Statement of Proposal for Consultation:

Subdivision and Development Bylaw 2026

Gore District Council

Attachment A – Amended Construction and Sightline Drawings

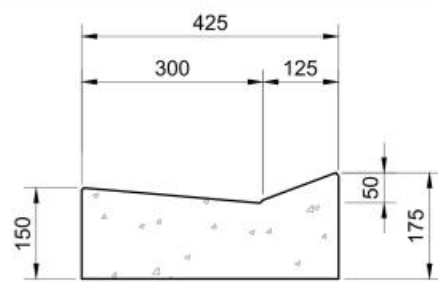
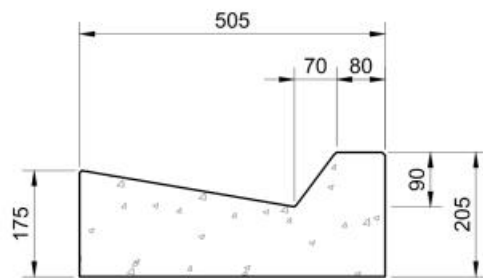
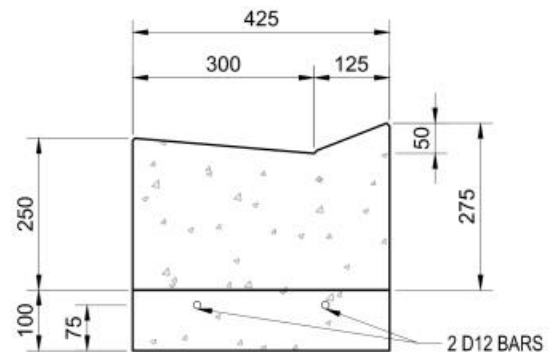
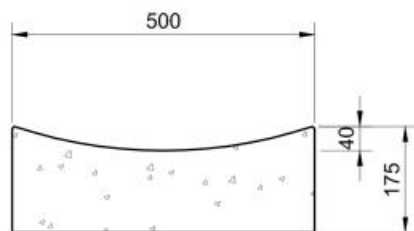
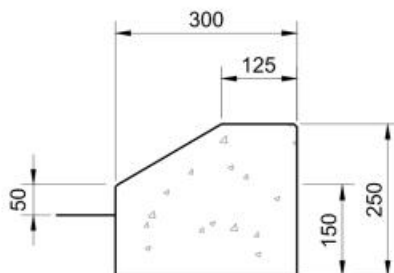
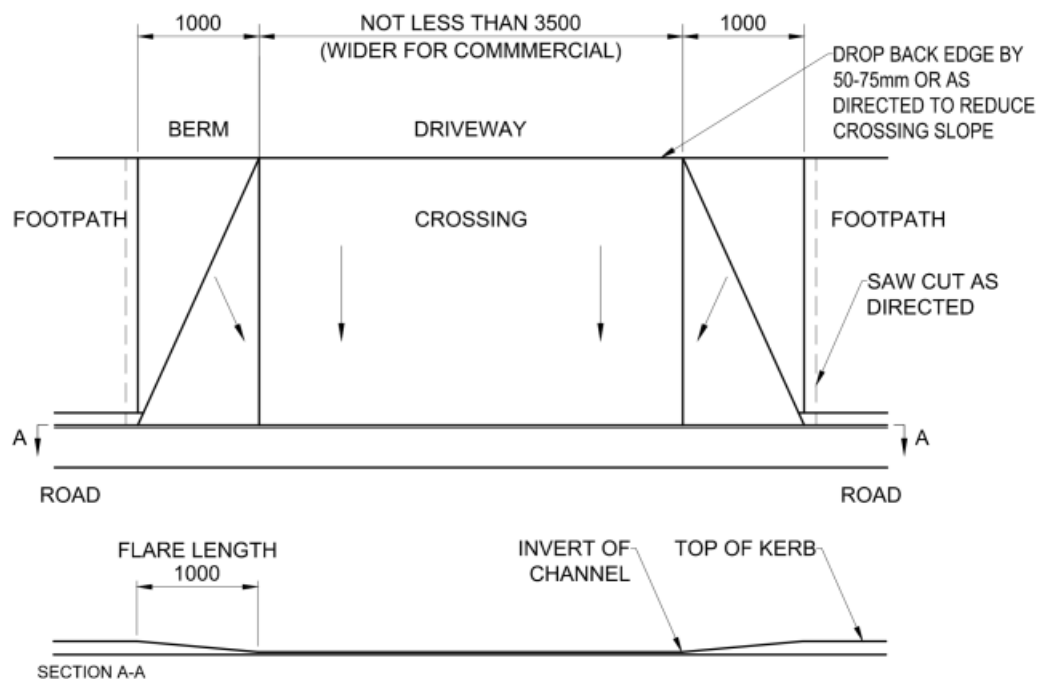
- Replace old One Network Road Classification (ONRC) with new national ONF categories in the chapter, tables, and construction drawings,
 - Update minimum surfacing and maximum gradient details,

- Update design and construction standards,
 - Update transport standard construction drawings,
 - Update or remove the following outdated Appendices:
 - F Accessway sight lines, and
